<b>Subject:</b>  <b>VIBRATION WHEN DRIVING AT 1500-1650 RPM</b>	<b>Bulletin No.:</b> 01-009/20
	<b>Last Issued:</b> 07/08/2020

2019-2020 Mazda3 (US spec)  
2020 CX-30 (US spec)

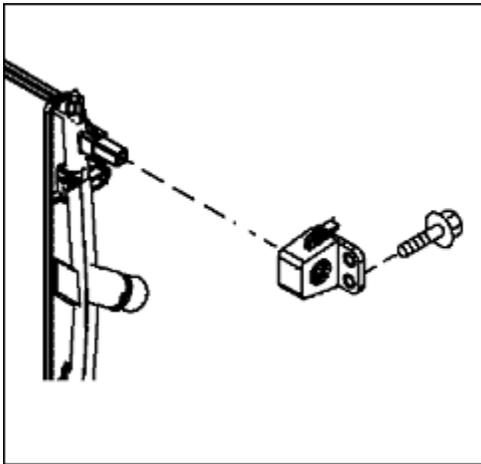
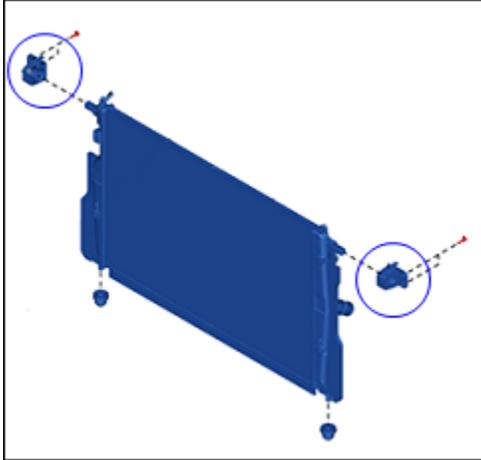
To correct this concern, the radiator mount brackets and the control software of the PCM have been modified to reduce the resonance of the radiator.

2. Replace the radiator mount brackets with modified ones.

**Bolt tightening torque: 71-88 in-lb (82-101 kgf-cm, 8-10 Nm)**
